Please find below the comment summary on SLP15062-1 Brock Commons Landscape and Civil Works. Respond to each item and return for our record. A resubmission of the Landscape set will be required once all comments have been satisfied.

**Brock Commons Phase 1**  
 6088 Walter Gage Road  
 University of British Columbia

**1 SOIL PROFILE**  
L6.01 NTS

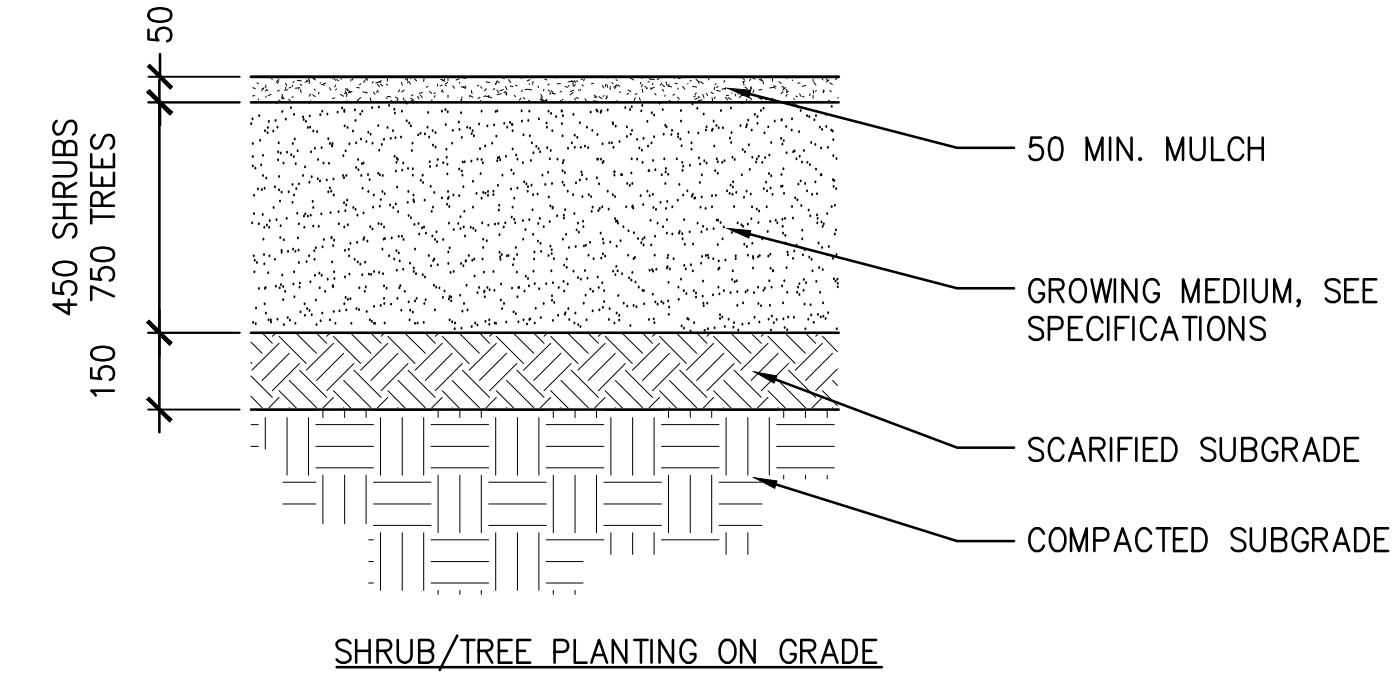
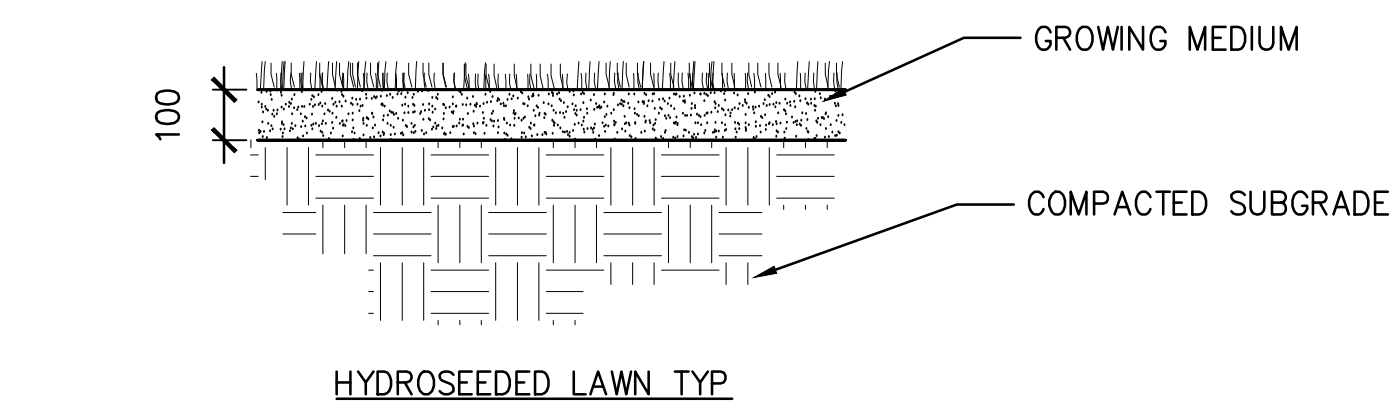
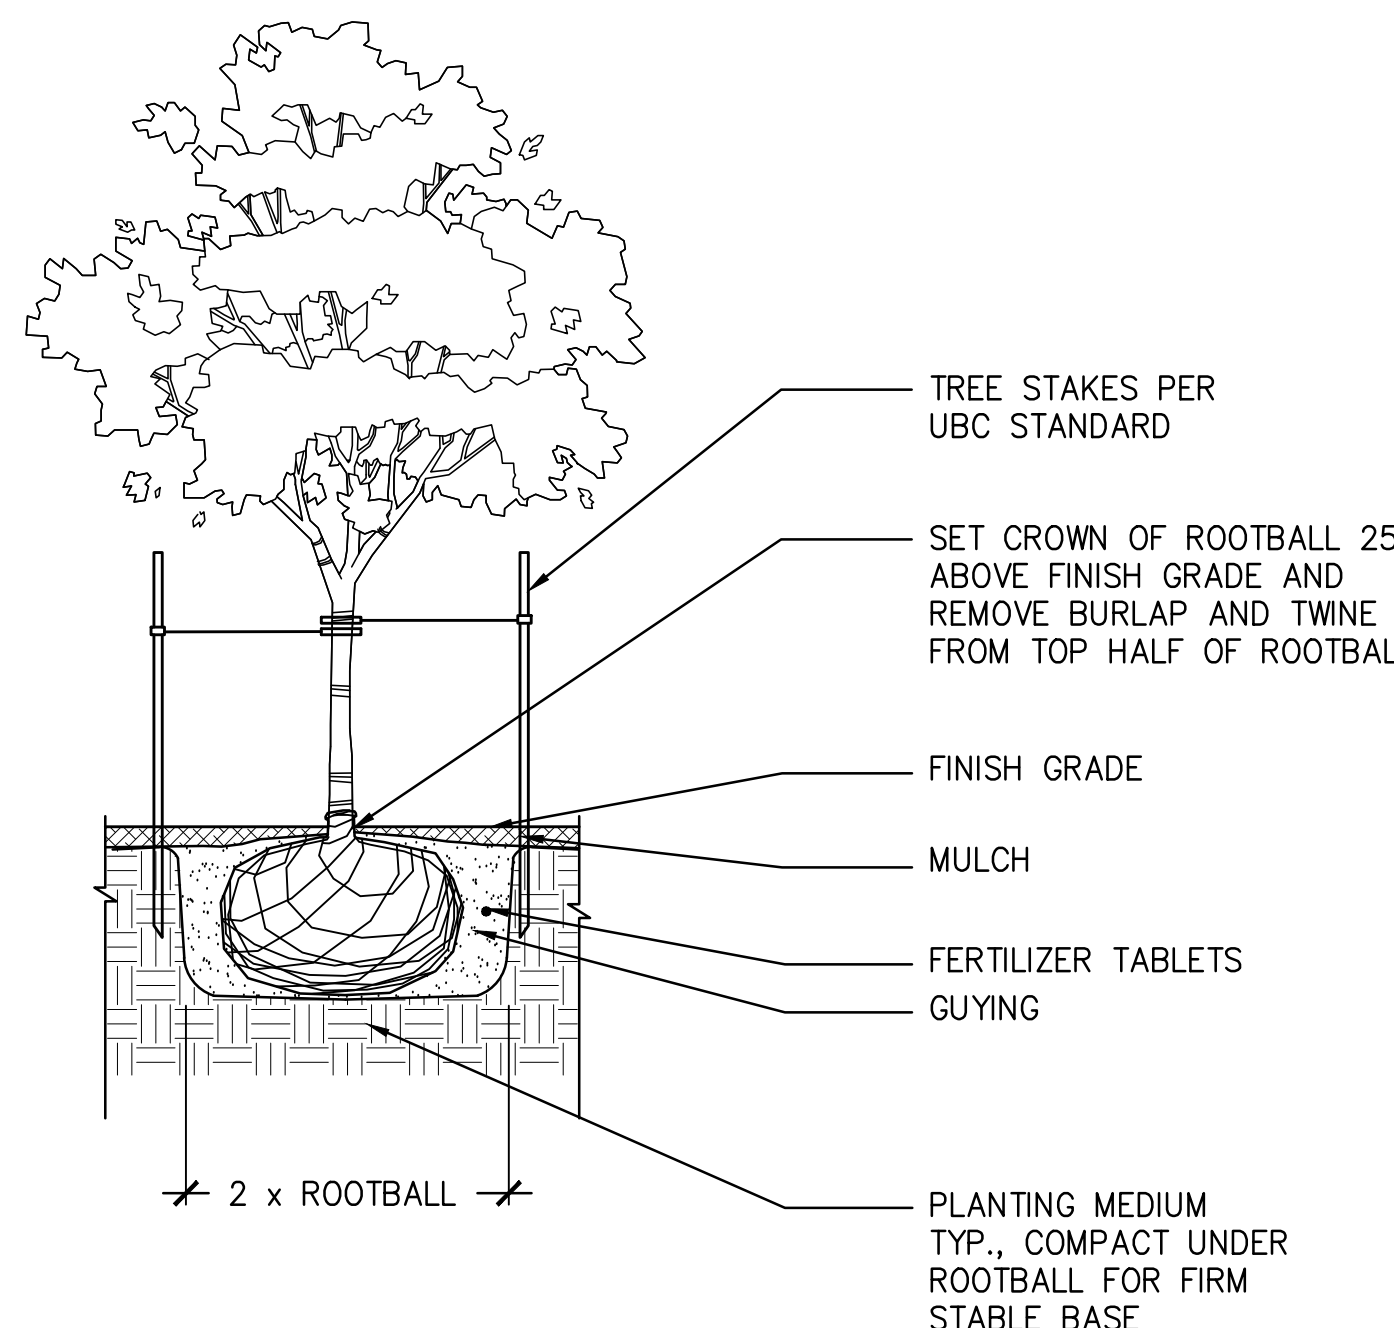
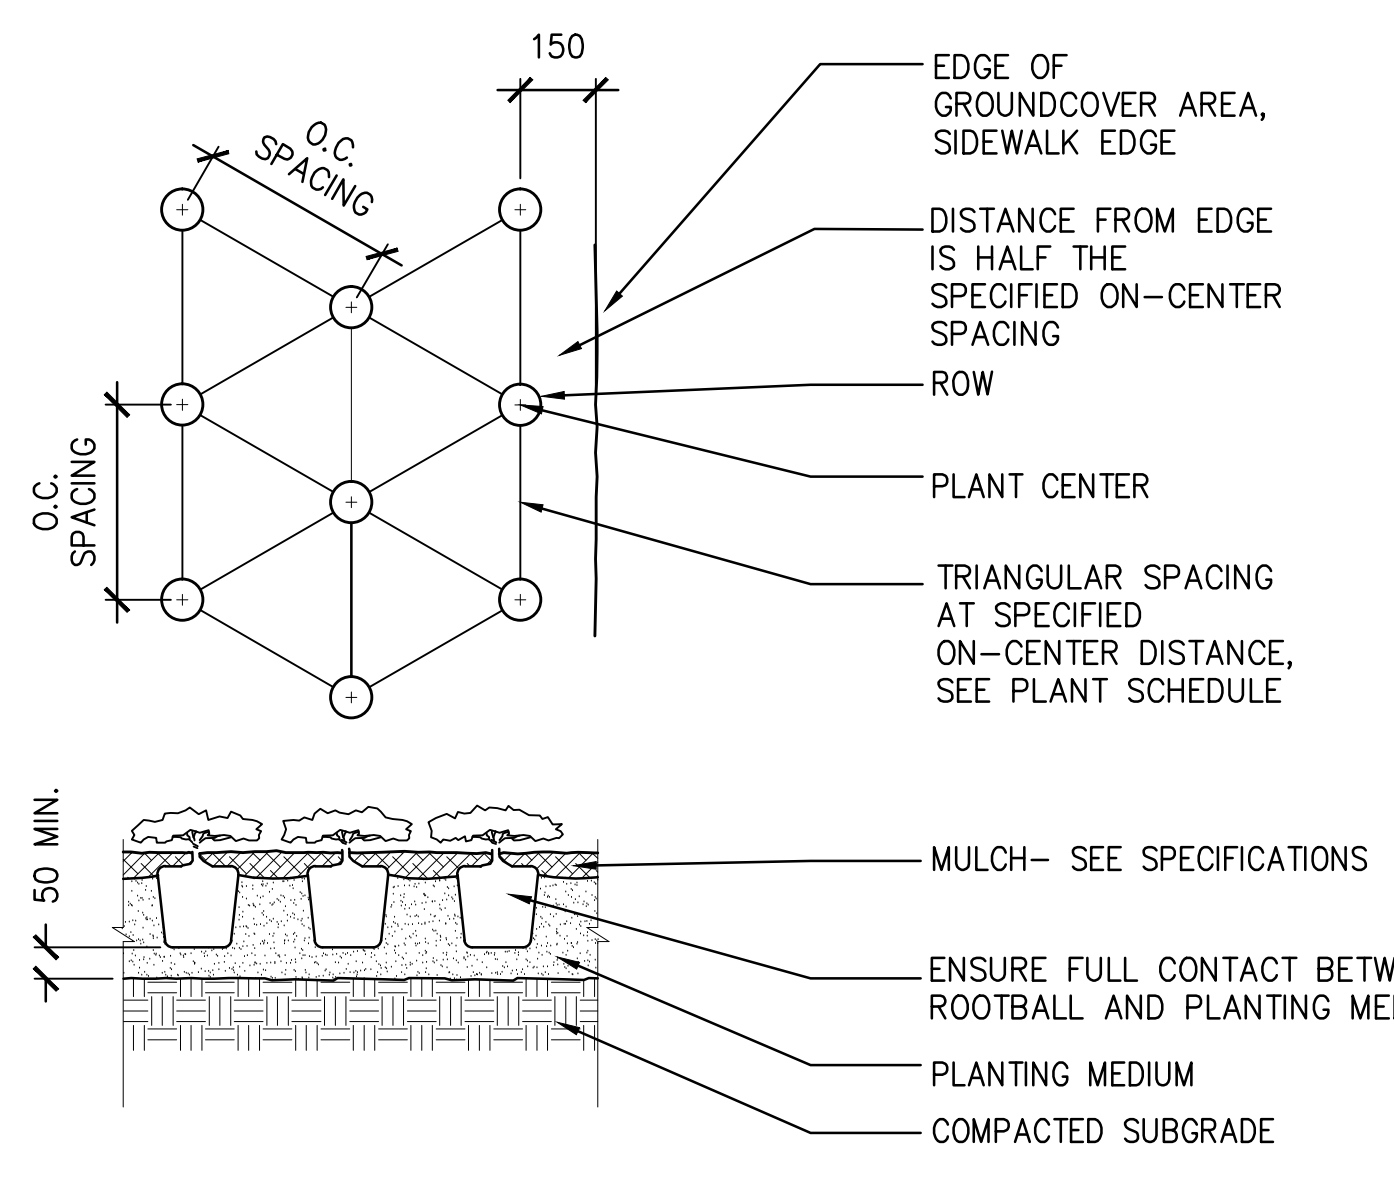
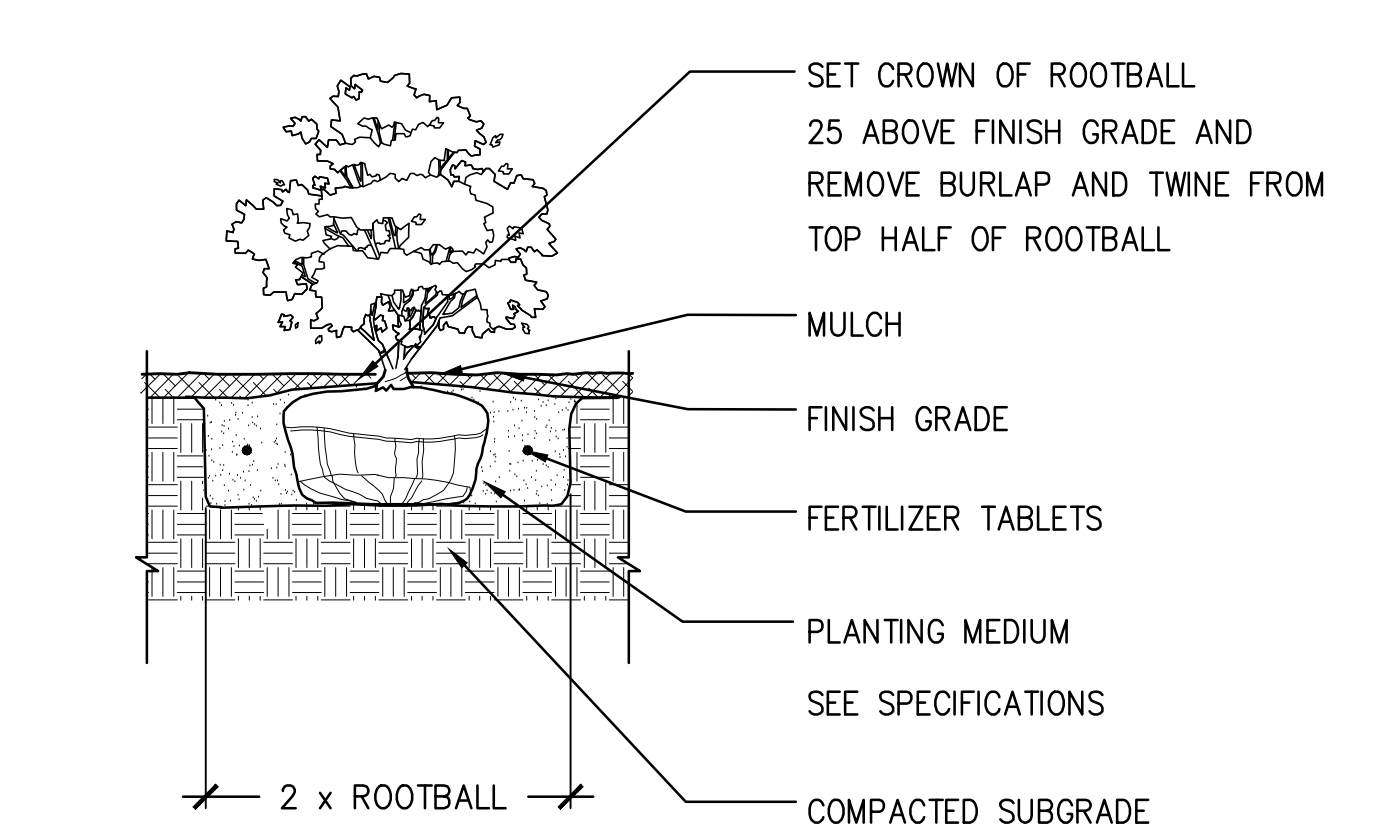
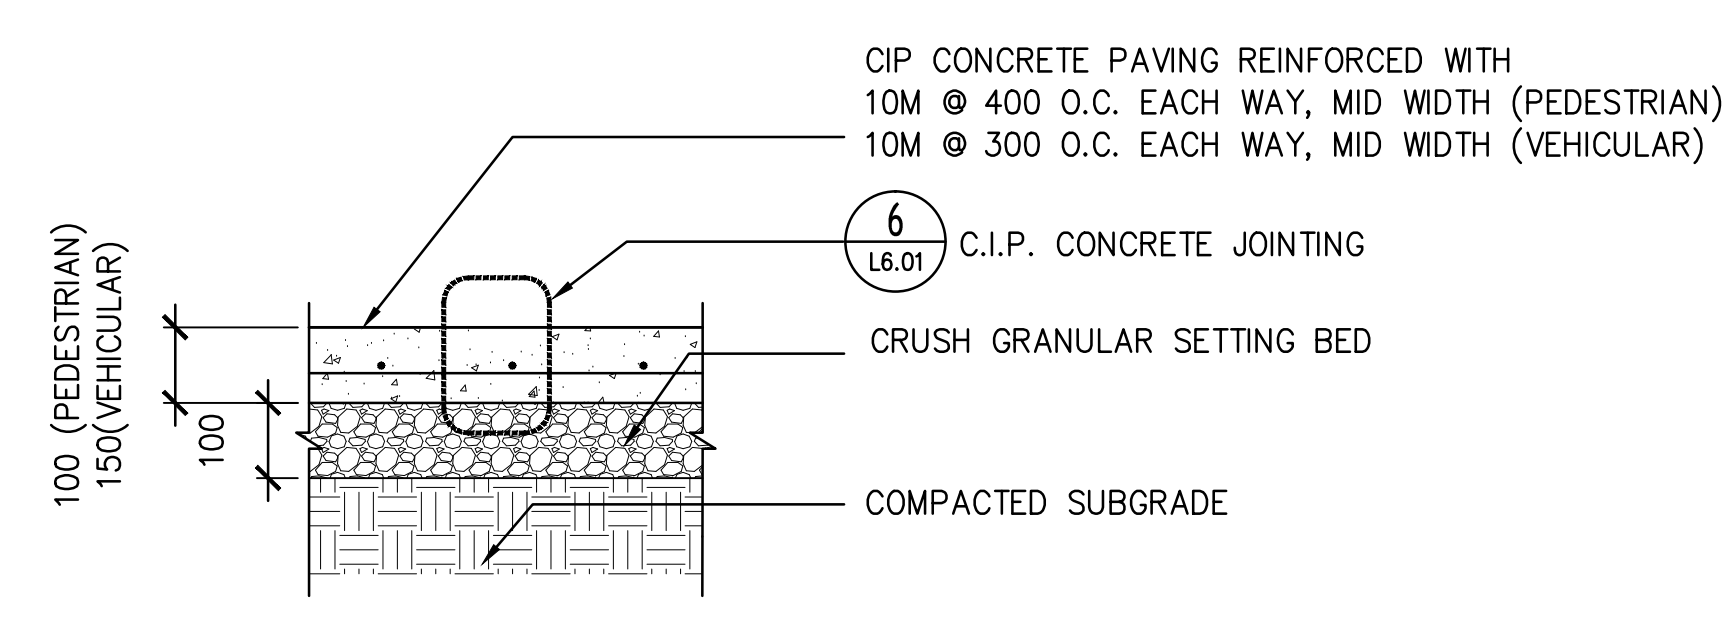
- L6.01: redesign metal edge at planter so that it doesn't present a trip hazard; as ground is the same grade on both sides of proposed edge, flush treatment is preferred and landscaping should be graded so that planting material migration is minimized as much as possible- *metal edge is deleted.*

**7 STREET TREE PLANTING**  
L6.01 1:40

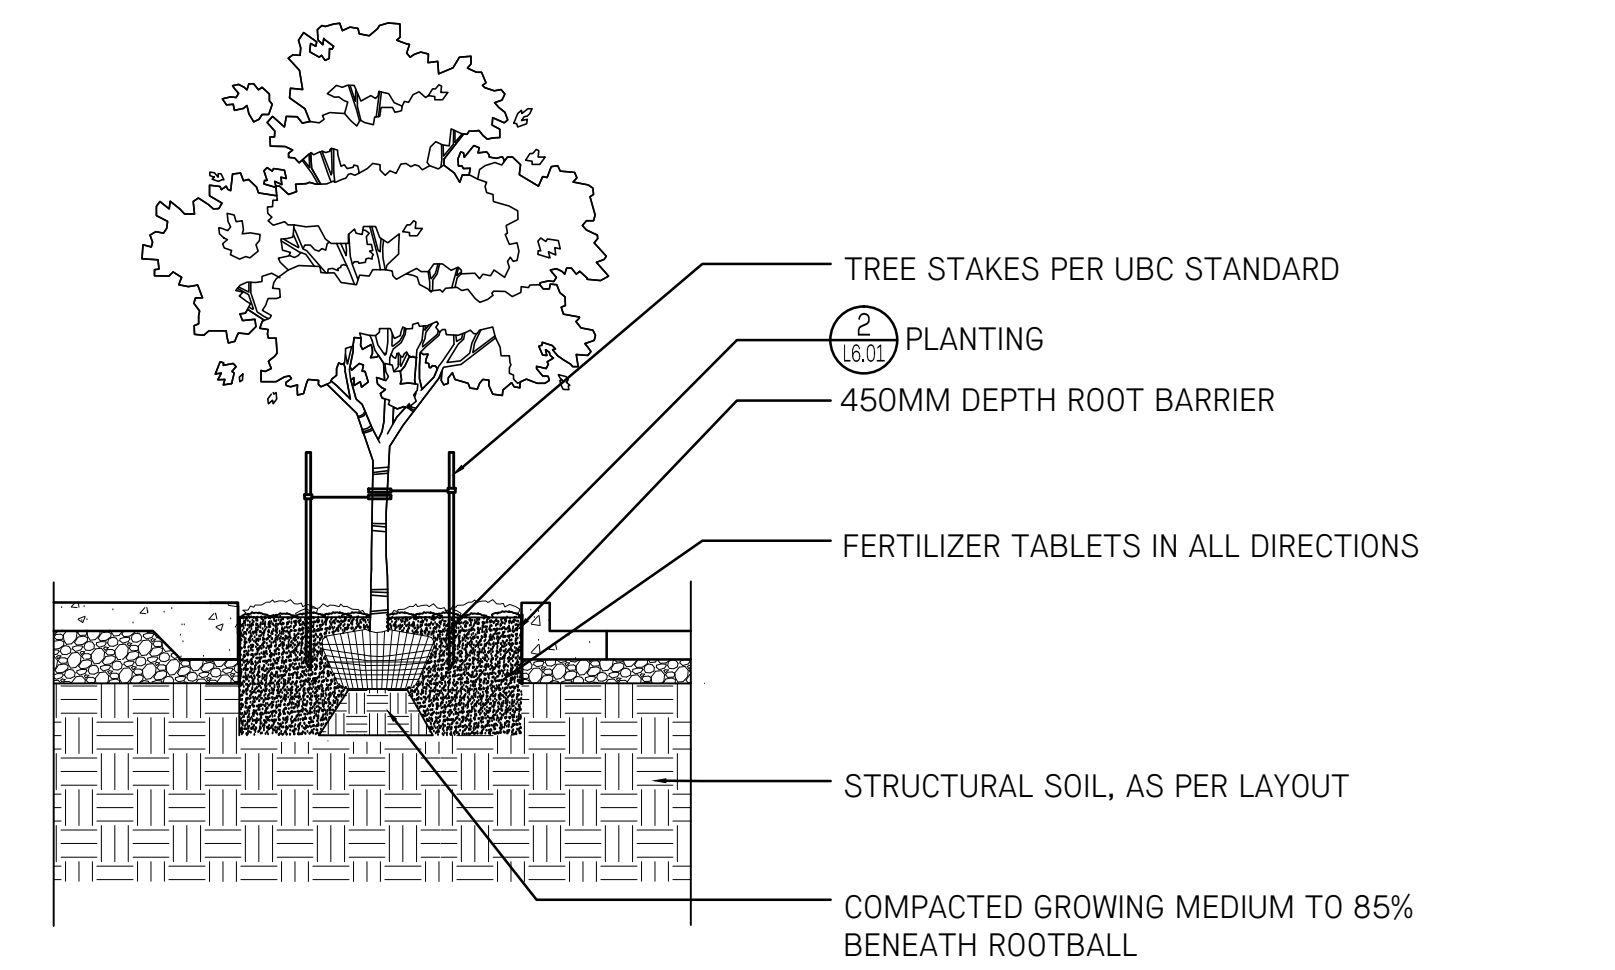
- Street Tree planting detail on L6.01 indicates structural soil "...as required". Seems too vague given current arboricultural science which confirms that small soil volumes=small or even stunted tree development. Structural cells are preferred over structural soil, but as minimum, consultant should do a calculation, verify and specify acceptable depth/width of structural soil under pavement. **The street tree specified along Walter Gage rd. is Quercus palustris 'Pringreen', which will only have 2m+/- canopy in 10 years, which is not referenced in town of Oakville guidelines or the soil volume chart we received. In this project, we referred to Canadian Landscape Standard which specified 6m<sup>2</sup>/soil per tree. (Please refer to attached copy). Please find L3.03 Tree & Structural soil layout plan showing structural soil extent. Calculation of the area is based on structural soil contains 20% soil, and the depth is 750mm.**
